Instituting a Proceeding to Investigate
Integrated Grid Planning.

DOCKET NO. 2018-0165

HAWAIIAN ELECTRIC COMPANIES'
REPLY TO PARTY COMMENTS AND COMMISSION QUESTIONS

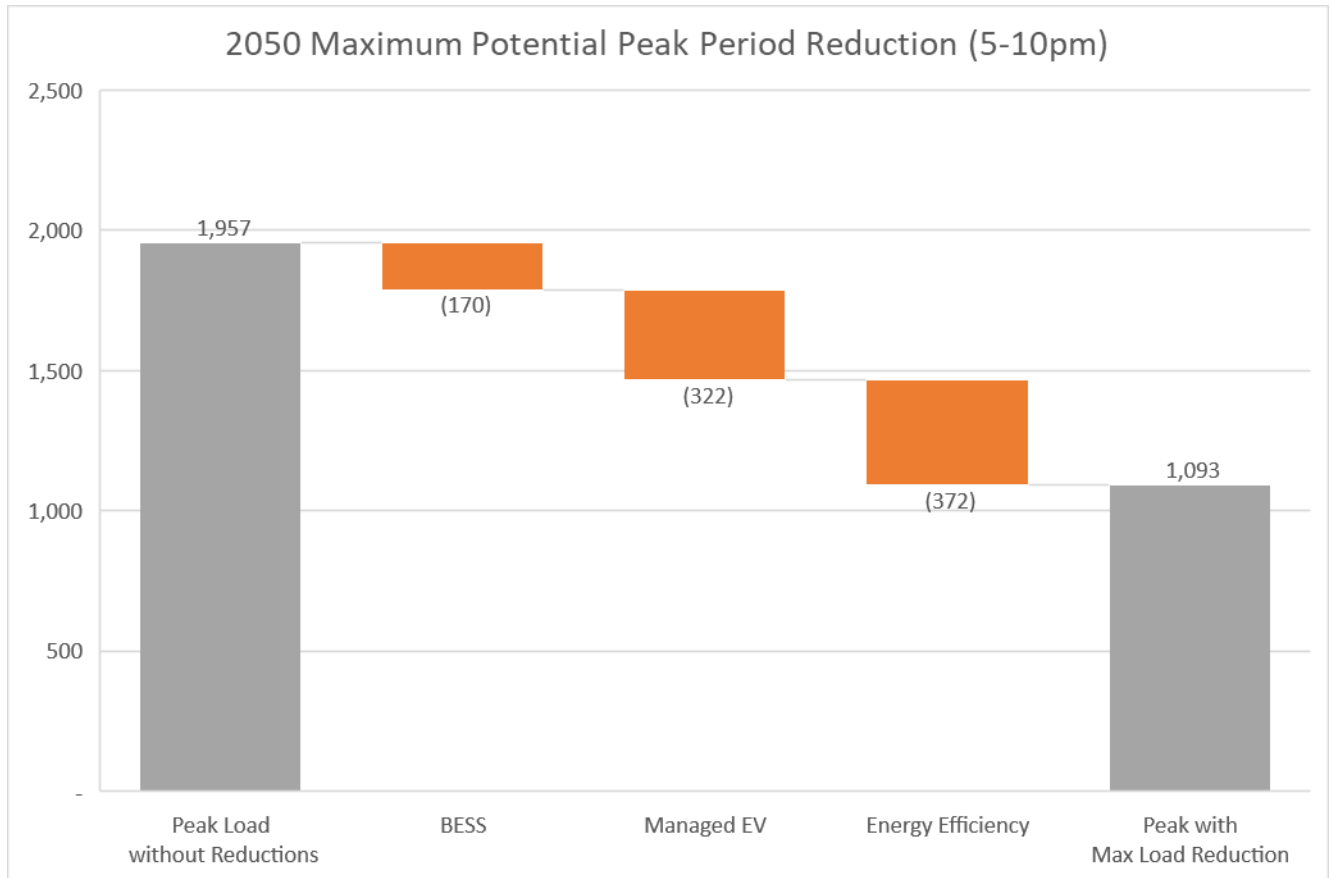
While the broad bookends proposed by Hawaiian Electric will likely provide useful information, a key for the future success of the IGP docket will be how this information is used and, if necessary, how the inputs and assumptions will be updated. If the intent is simply to tweak the existing base case, then this exercise will be futile. Instead, the bookends and future sensitivities should inform a series of preferred options that accelerate progress towards Hawai‘i’s clean energy mandate.

For example, the Brattle Electrification study for Pepco’s climate plan estimates significant load growth as a result of rising levels of electrification. Nonetheless, Pepco anticipates energy efficiency and load flexibility (including residential behind the meter storage) will reduce peak demand growth by 40% between now and 2050 (*see Fig. 1*). Pepco also states it believes it can manage this peak demand growth at the distribution system level. It is hoped that Hawaiian Electric is viewing the current bookends with the intent to examine the feasibility and likelihood of a similar result and accelerated RPS coming out of the IGP process.⁴³ (actual figure and footnotes omitted)

The base case is intended to represent what is most likely to occur based on econometric models, market factors, and current and projected policies. The Companies, upon the recommendation of the TAP, developed high and low bookend scenarios. As stated by the TAP,
